**System Impact Assessment for
Prince Park Wind Development Project
Applicant: Superior Wind Energy Inc.
Final Report**

CAA ID 2004-117

April 14, 2005

Prince Park Wind Development Project

FIGURE 1 : PROPOSED CONNECTION

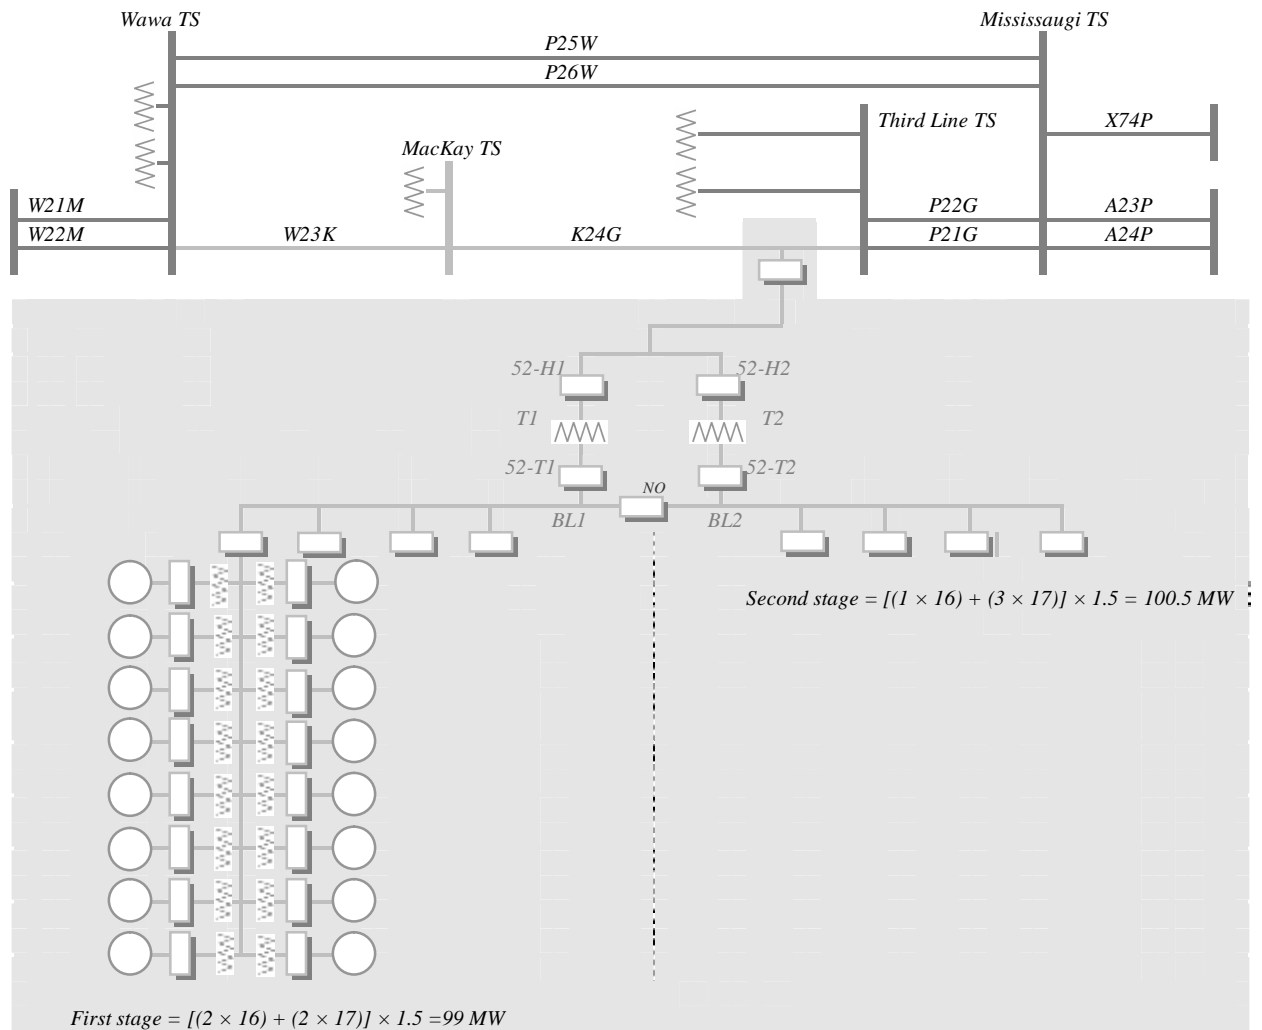
After completion of stage 1 or stage 1+2, the net impedance between the machine terminals and the existing IESO-controlled grid would be exceeding 0.13 pu on facility MVA base. This would mean the total reactive power from the generators would not be available for voltage regulation of the existing 230 kV system due to excessive reactive power losses occurring between the machine terminals and the existing IESO-controlled grid. Thus, reactive power compensation must be provided by the applicant. The amounts of reactive power compensation required for each stage are given in Section 8.0.

For the Prince Park project, the exact length of the new 230 kV tap is 14.74 km. Thus, it is required that a 230 kV breaker be installed at the point of connection of Prince Park power injection to the new K24G circuit. The breaker is required to have an adequate short circuit current interrupting capability exceeding the asymmetrical fault levels in 3 cycles according to the Transmission System Code requirements.

2. It is required that a new 230 kV circuit breaker be installed at the tap point of the Prince Park facility to the K24G circuit. This breaker is required to be rated for continuous operation at 260 kV and have an appropriate short circuit current interrupting capability exceeding asymmetrical fault levels in 3 cycles.

5. If transformer HT breakers 52-H1 and 52-H2 are replaced with motorized disconnect switches, it would be acceptable to the IESO in terms of reliability and security of the IESO-controlled grid only if,

FIGURE 2 – STANDARD FOR SETTING UNDER-FREQUENCY TRIP PROTECTION FOR NEW GENERATORS

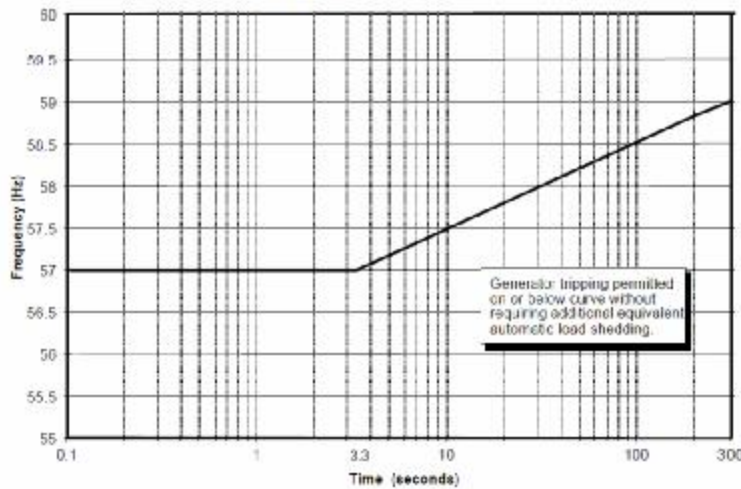
Appendix 4.2 of the Market Rules requires that generators be able to operate continuously with available active power output for system frequencies between 59.4 to 60.6 Hz. For under-frequency system conditions, the generators shall not trip for frequency variations that are above the curve shown in Figure 2.

9. It is required that for under frequency system conditions the generators must not trip for frequency variations that are above the curve in Figure 2 of this report.

FIGURE 3 – VARIATION OF MACHINE TERMINAL VOLTAGE

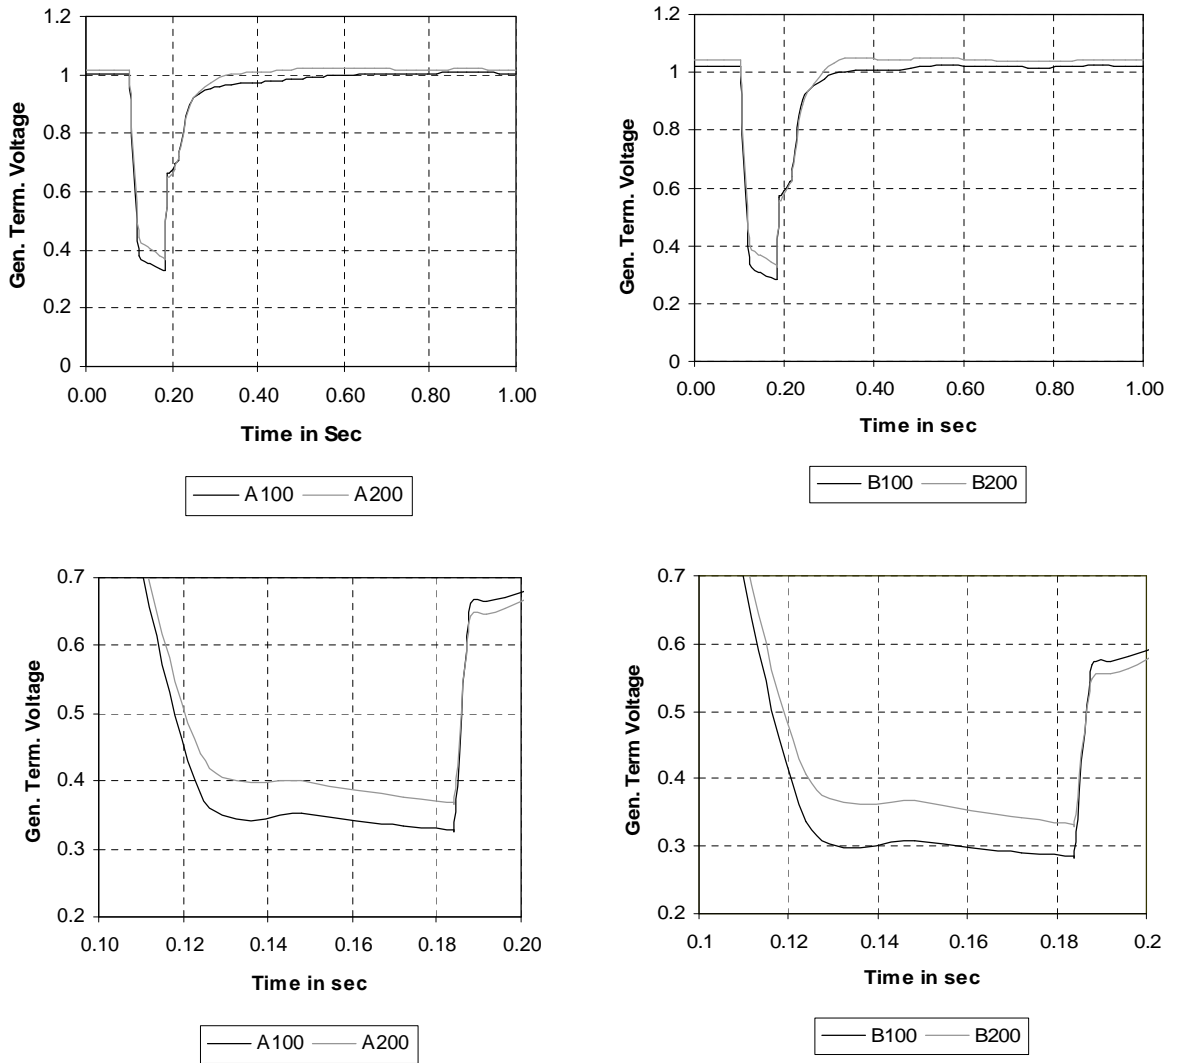
The 100-200 ms plot shows the duration during which the generator terminal voltage drops below 0.7 pu where without the LVRT, the generators would potentially trip by under-voltage protection.

The durations for 1.0 - 0.7 pu voltage drops are given for fault-on systems. For the LLG fault at P22G at Third Line TS, the generator terminal voltage would drop below 0.7 pu for 90 ms for scenario A₁₀₀ and for 88 ms for the scenario A₂₀₀. Similarly, the generator terminal voltage would drop below 0.7 pu for 116 ms for scenario B₁₀₀ and for 112 ms for the scenario B₂₀₀. Thus, without LVRT capability the generators would instantaneously trip.

Even if the generators are equipped with Level 1 of LVRT capability, still the generators would instantaneously trip as the terminal voltage would drop below 0.3 pu for 26 ms for the scenario B₁₀₀.

Simulation results show that the generators must be equipped with Level II of LVRT capability to remain connected to the IESO-controlled grid during contingencies for which the generators are not removed by configuration. However, it must be strongly emphasized that the IESO has serious reservations on the currently available PSS/E dynamic model for induction generators and consequently, the conclusions on LVRT drawn from transient simulations are not necessarily accurate or dependable.
